Addendum No. 4

RFP No. 23-29
FIRE TRAINING CENTER SITE CONSTRUCTION
SERVICES

March 20, 2024

ROCKDALE COUNTY FIRE TRAINING CAMPUS

Sheet No.: **C-7.00**
NOT RELEASED FOR CONSTRUCTION

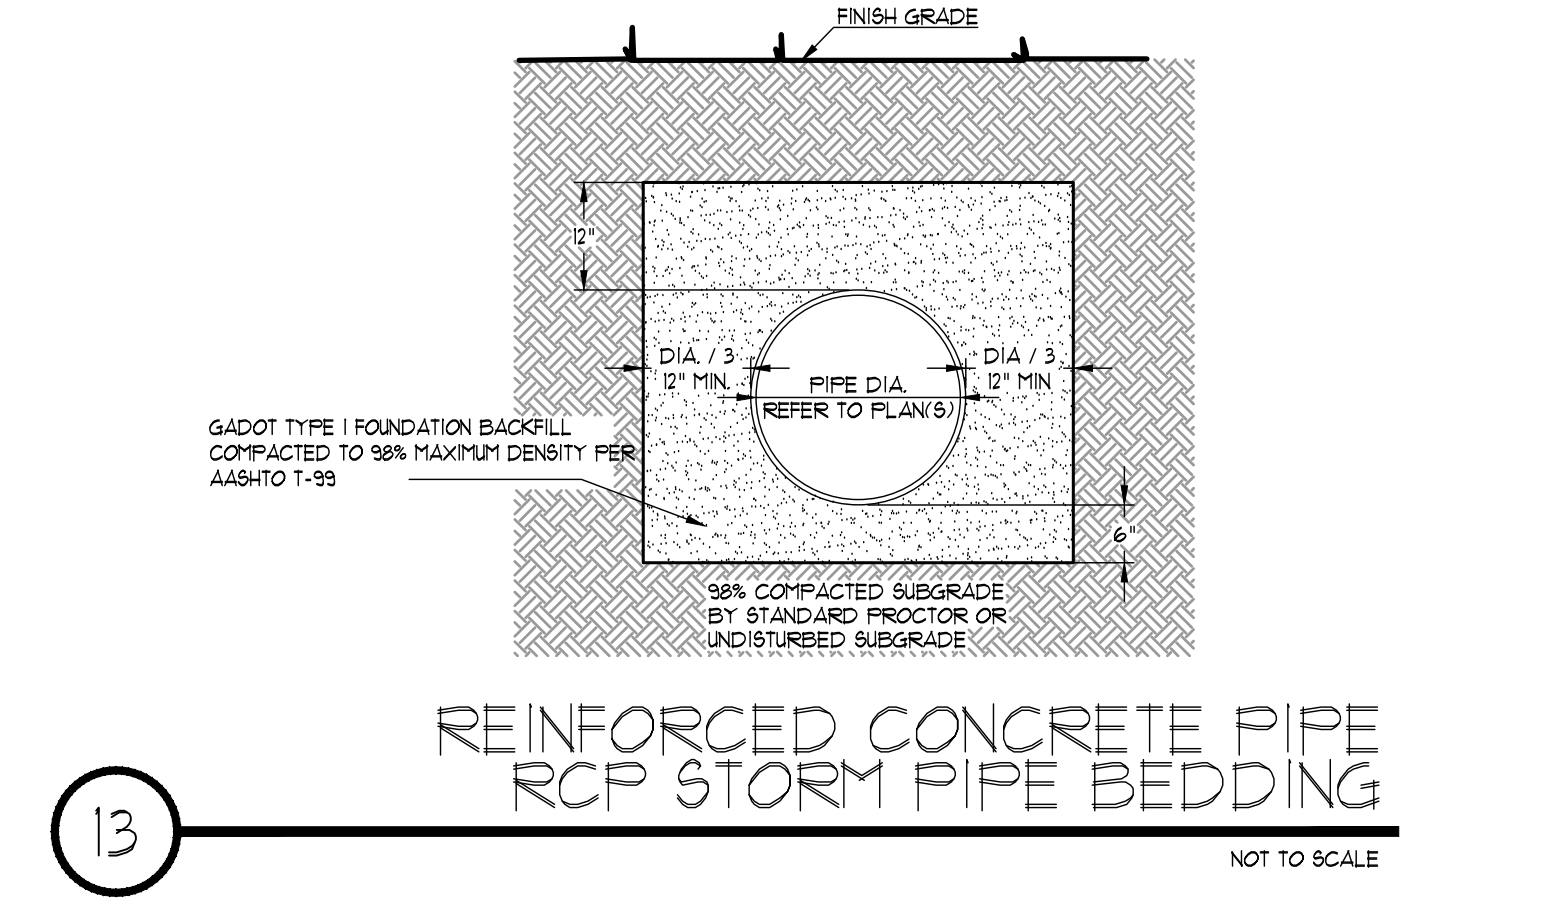
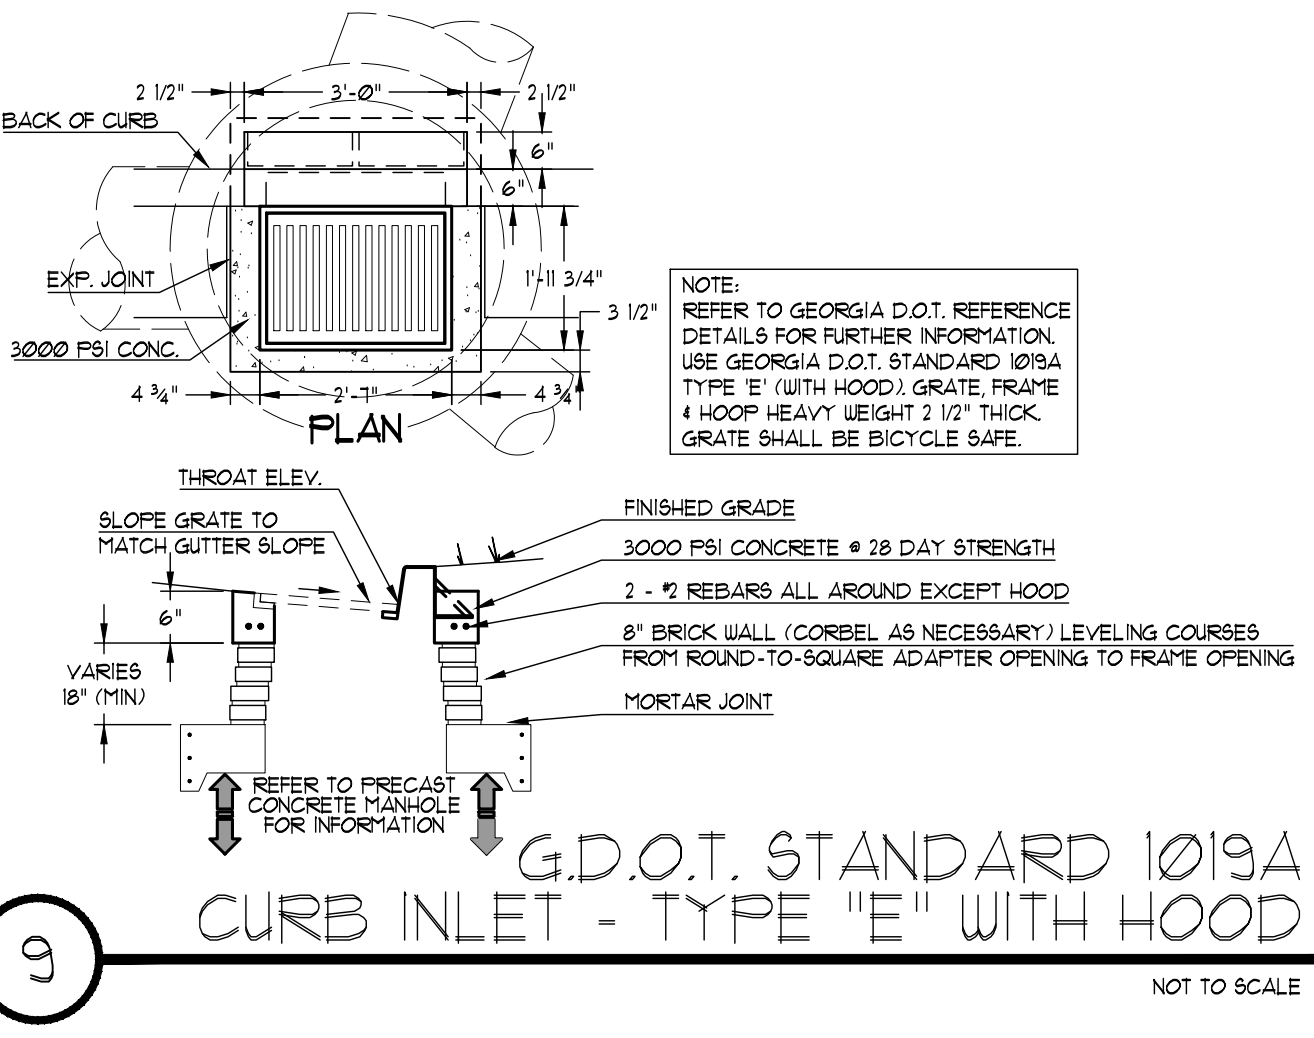
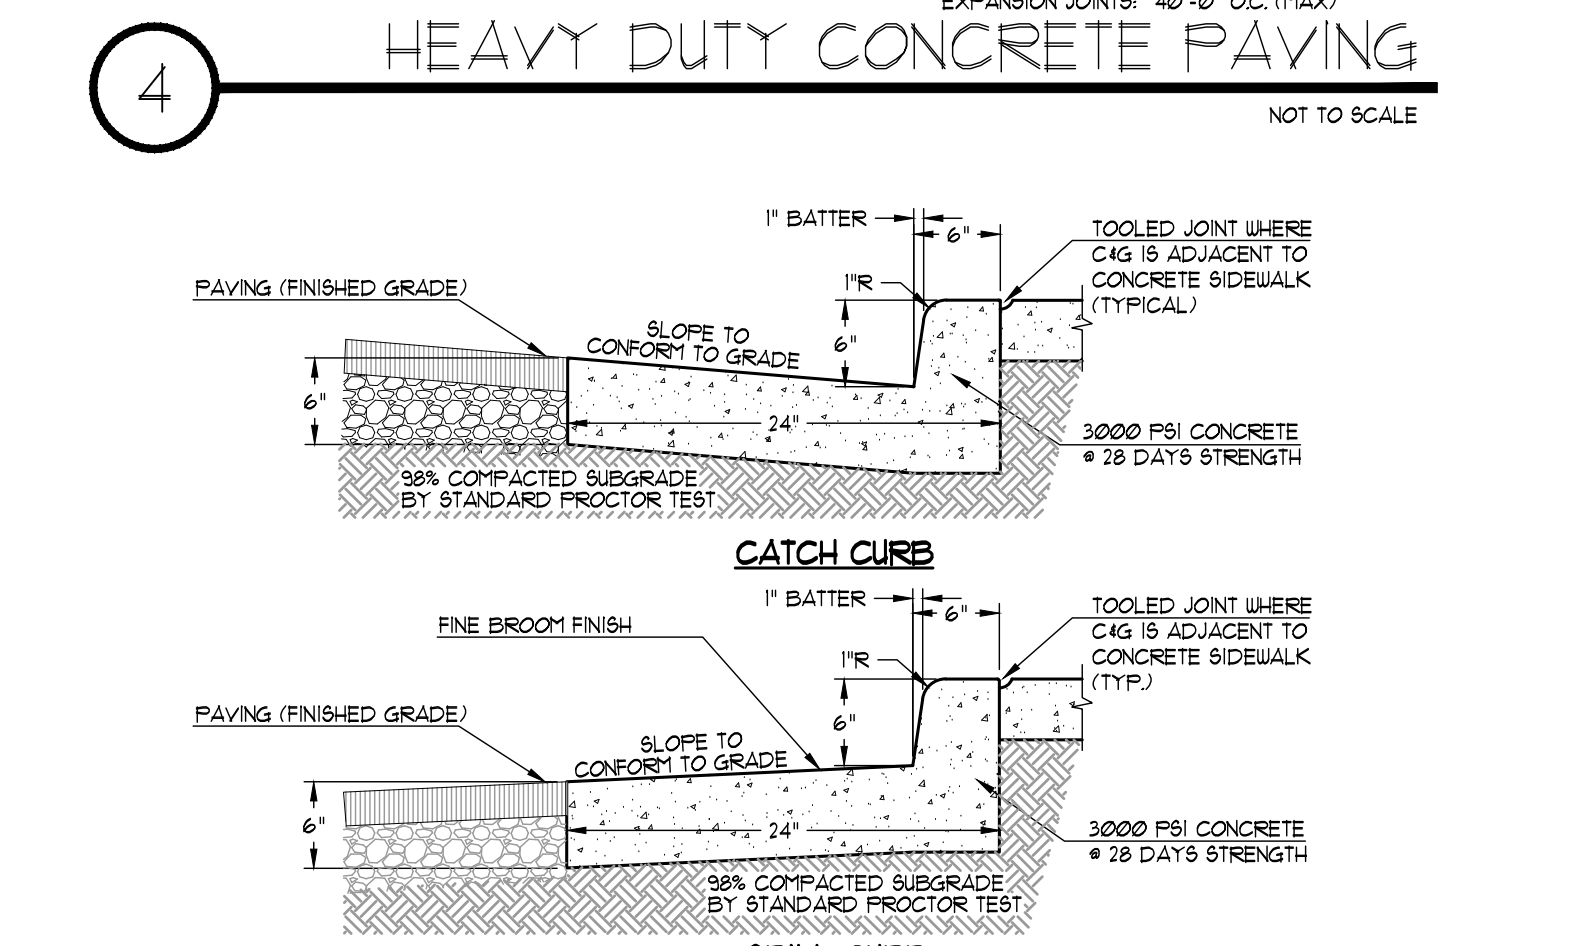
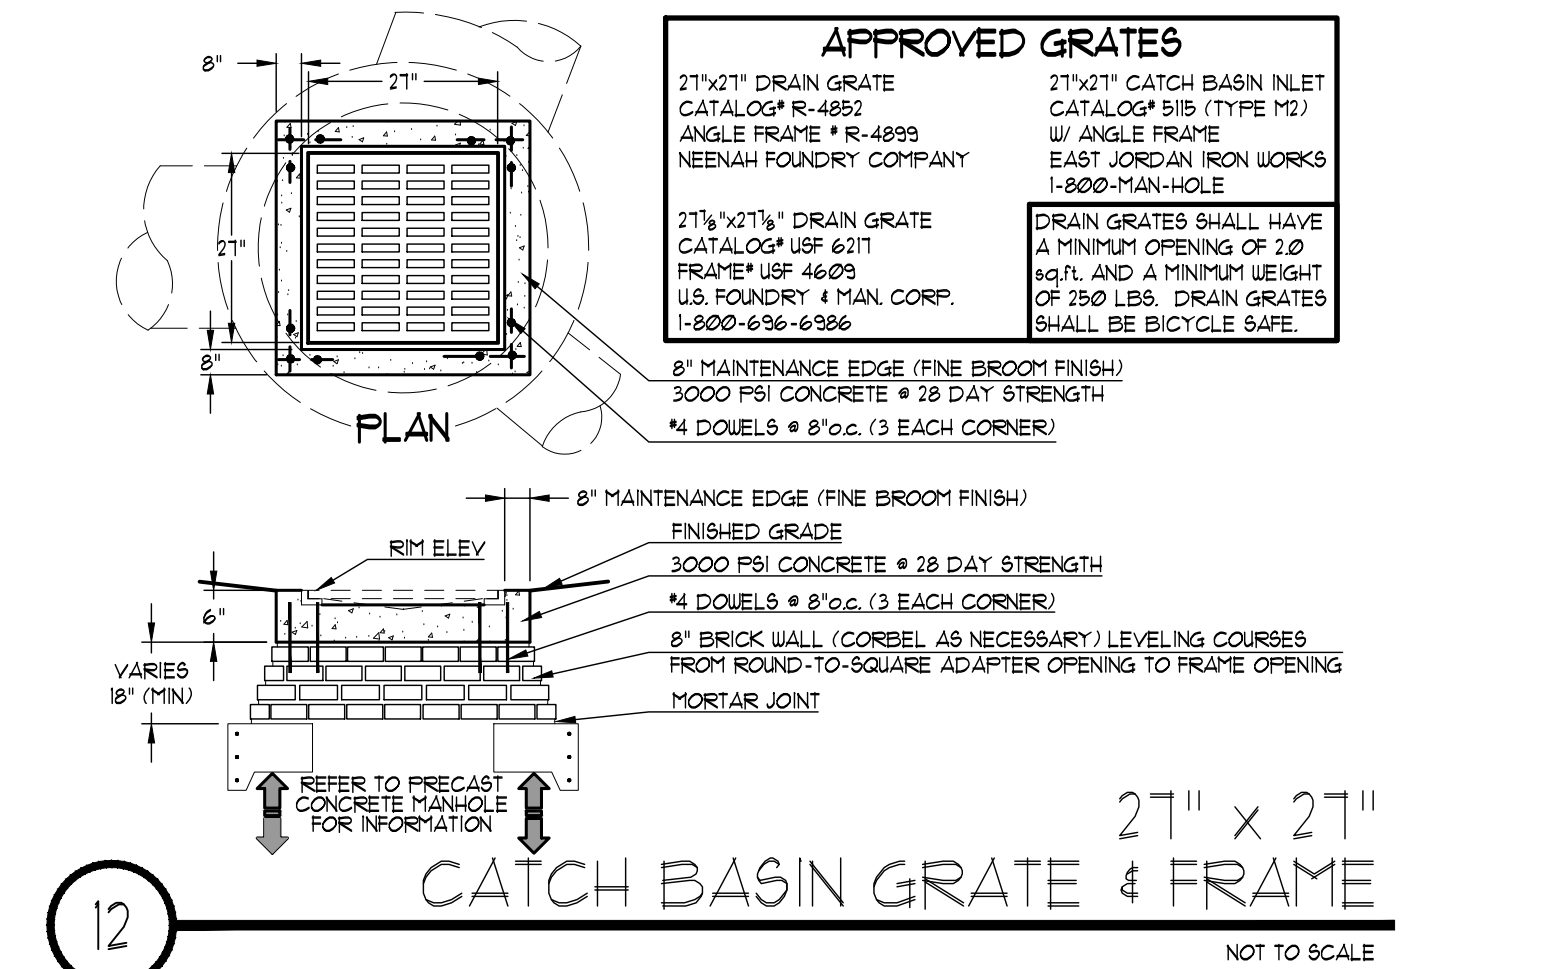
B. Question: C-3.10 & C-3.20 both show storm drains lines A1-A2 and A3-A4 as HDPE, but detail sheet C-7.00 shows both storm drain lines as RCP. Please clarify.

Answer: Storm pipe shall be HDPE. Details 1 and 2 on C-7.00 have been corrected.

C-7.10

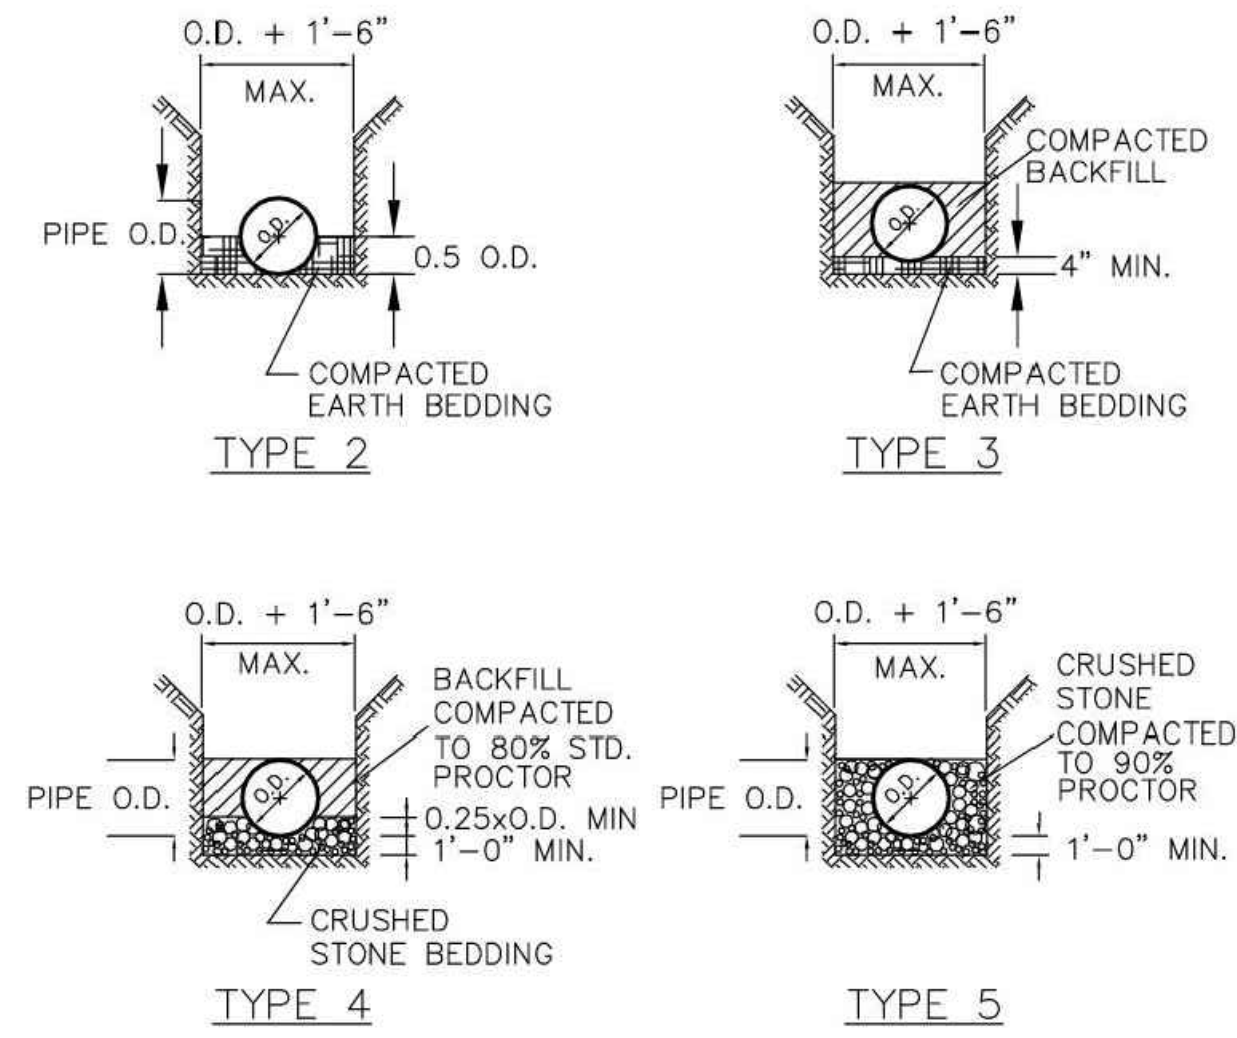
C. Question: Utility sheet C-500 calls for an 8" fire meter but says to follow Rockdale Water Resources Standard Drawing No. A22. Drawing A22 is not a full flow fire meter detail. It is a double backflow with a low flow bypass meter for fire line and a separate domestic meter and backflow. Rockdale county spec also allows a combination fire and domestic meter vault (detail A-20 sheet C7.11). Are we following Rockdale specs per drawing No. A-22 or A-20?

Answer: Details A-20 and A-22 have been removed. Contractor shall follow details A-12 and A-21 which have been added to C-7.10 and C-7.11.

STANDARD DRAWING No. A-15

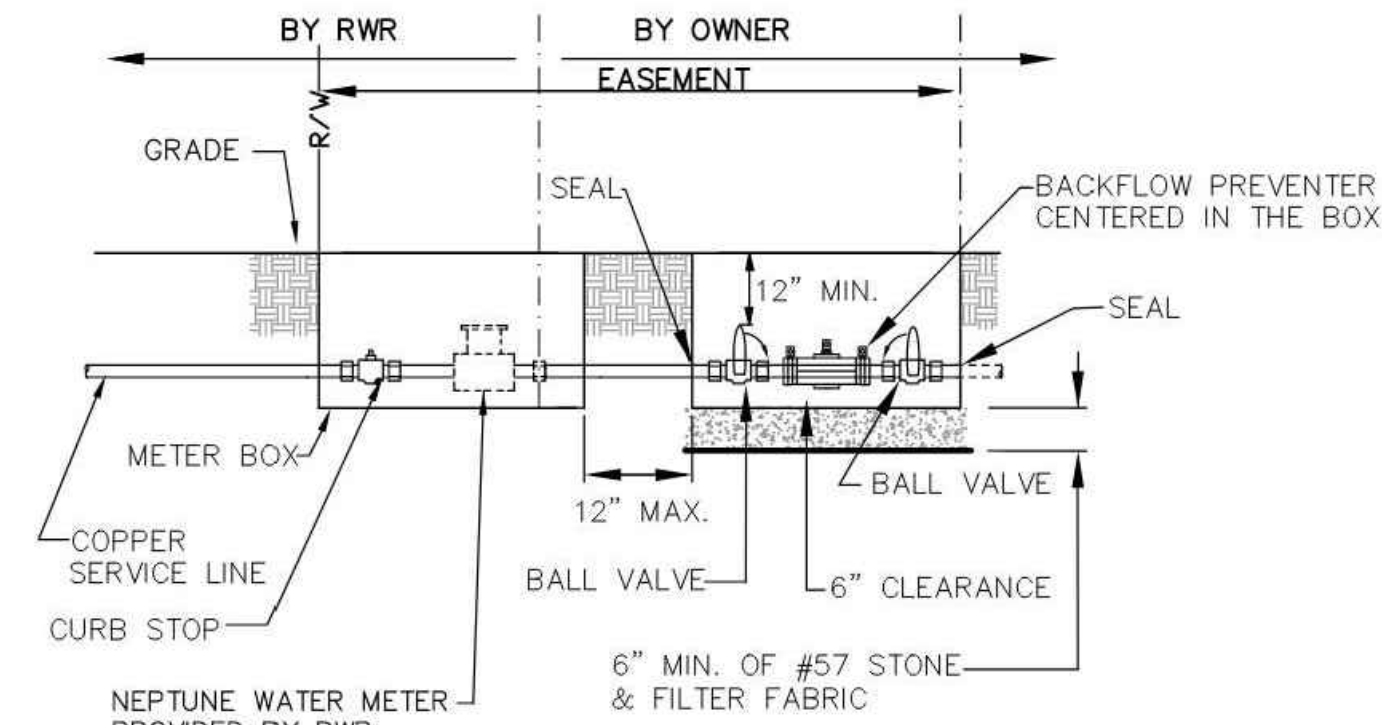
D. Question: How do you want to handle driveway crossings at the water main extension? I can cap with GAB or concrete or asphalt. How do you want to handle it?

Answer: Refer to Rockdale Water Resources Standard Drawing No. A-15 on C-7.00. Contractor shall utilize Type 5 laying condition combined with detail 3 on C-7.00, Heavy Duty Asphalt Paving.
